STATUS CHECK		Residential 1 & 2 Family Permit		Application # 01-176348-000-00-RS	
Status Date: January 10, 2002				IVR Number: 2140344	
APPLICANT GROVE DEVELOPMENT INC		Phone: (503) 977-2166			
OWNER VIRGINIA H ROBINSON		Phone:			
CONTRACTOR GROVE DEVELOPMENT INC		Phone:			
PROJECT INFORMATION		Description of Work: NSFR- PARTITION PLAT2001-129 PARCEL 3			
Street 4709 SW FLOWER CT					
Address					
Occupancy Group	Construction Type	Sub Type	Work Proposed		
R3 U1	V-N	Single Family Dwelling	New Construction		
This report shows those reviews which have been assigned as of January 10, 2002 at 9:13 am. Technical reviews may trigger additional review assignments.					
Review Type/Process	Mandatory	Status	Action Date	Reviewer	Phone
Completeness Check - RS	X	Closed	1/10/02	Heltman, Nancy	503-823-7360
Process Manager		Open		Hansen, Keith	503-823-0655
Assign plan and file location		Closed	12/19/01	Hansen, Keith	503-823-0655

BES PLAN EXAMINATION CHECK SHEET

LIFE SAFETY CHECKSHEET

Street Address:	4709 SW FLOWER CT					
Description of Work:	NSFR- PARTITION PLAT2001-129 PARCEL 3					
The following assumptions were made when reviewing your project:						
Occupancy group	Construction Type	Square

Sand Filter

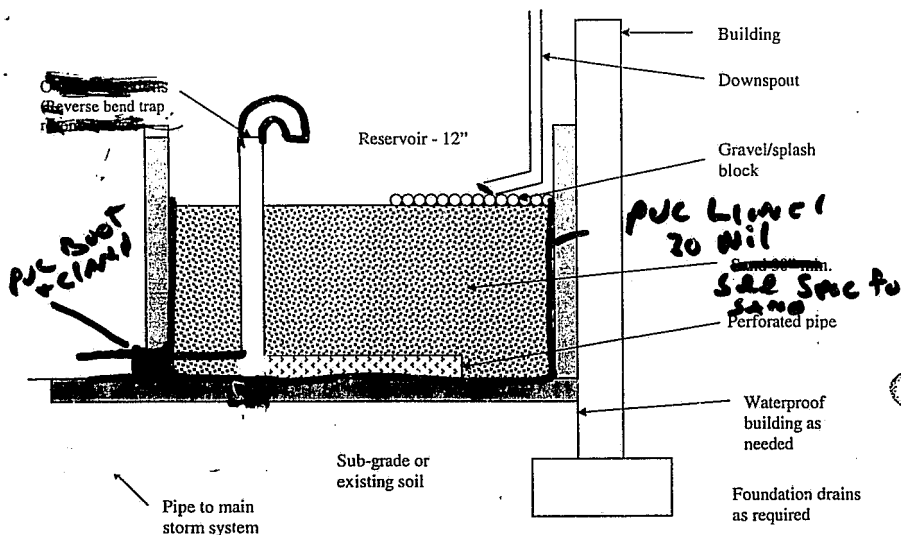
Item #	Location on plans	Clarifications / Corrections Required
1.	Site Plan - 01-176348-RS	Your submitted SIM Form does not indicate the amount of Non-Mitigated Impervious area to be treated by your stormwater facility (sand filter). Please properly complete the SIM Form and return to Document Services as prescribed below.
2.	01-176344-RS	Per your conversation with Judy Russell, please also properly complete the SIM Form for 4710 SW Cameron Rd. and submit as prescribed below NOTE: You may submit these forms concurrently with the O&M Forms you will be submitting for all four lots in the development, as per our prior conversation.
